PHILIPS

OSC 60

OSCILLOSCOPE PM 3234

Already published: OSC 13 - OSC 26.
 Subject: Flash-over problem inside C.R.T.

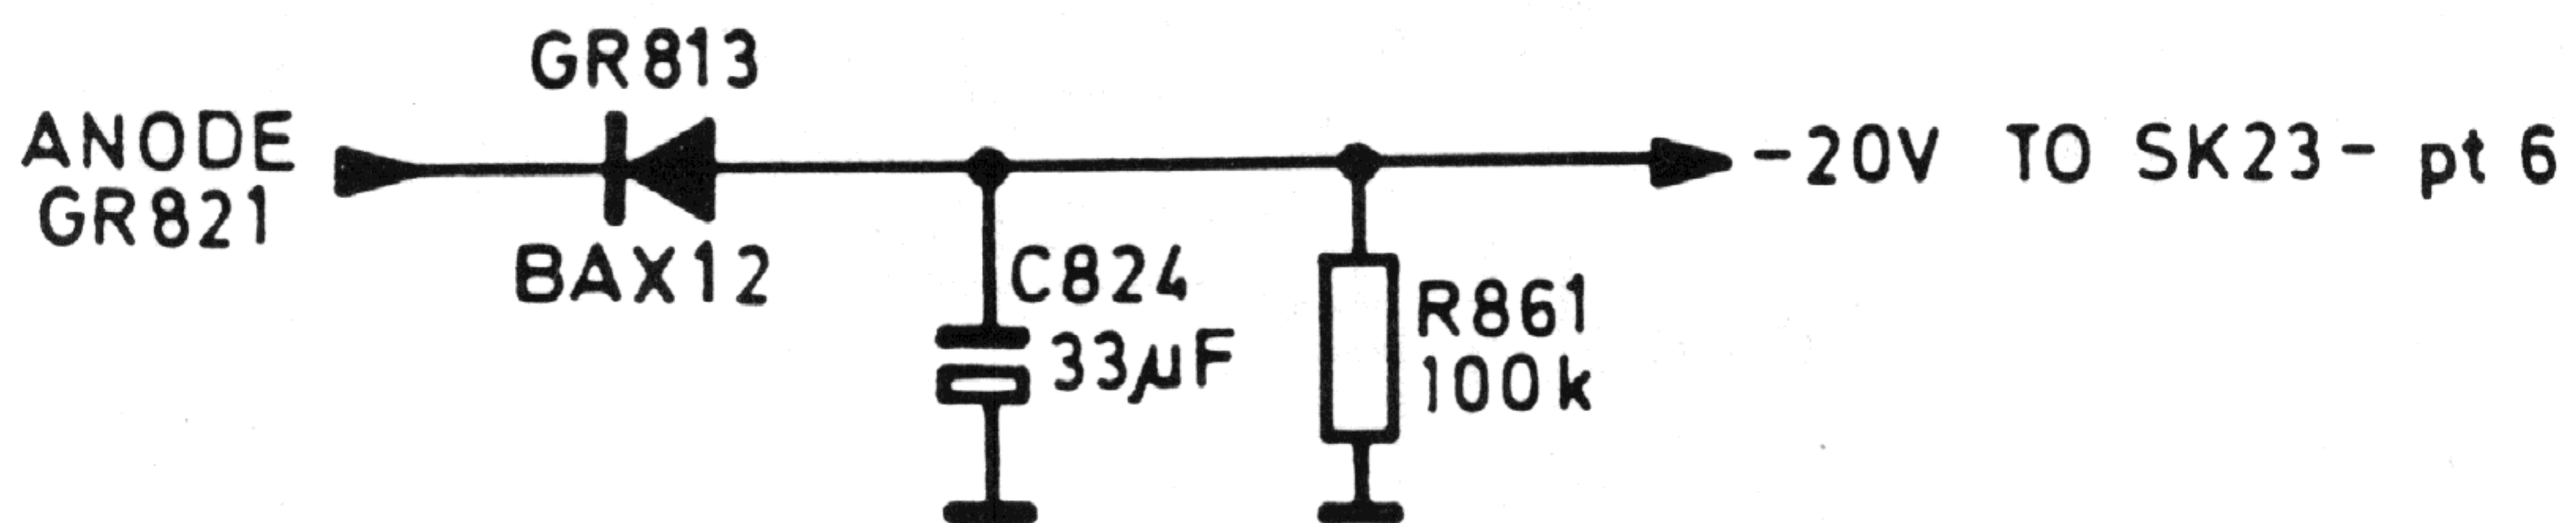
- In some instruments flash-over inside the C.R.T. occurs.
 The C.R.T. display remains then more or less green instead of just black, after pushing the ERASE-button.
DON'T REPLACE THE C.R.T. unless you have tried the following modification.
 In most cases a solution to this problem can be found by replacement of the E.H.T. unit by a modified one.
 This modified type of E.H.T. unit has a reduced internal resistance (R_i).
 The modified E.H.T. unit will be delivered under the old service ordering number: 5322 216 54109 and can be recognized by the number 4022 246 0235 which is printed on its housing.
 (The new unit can also be used for service replacement in older instruments.)

- During the production of the /12 version a modification is introduced to increase the memory off voltage from -30 V to -50 V , because of changed C.R.T. specification.

The print track between SK23 pt6 and R1043 on the storage unit is interrupted.
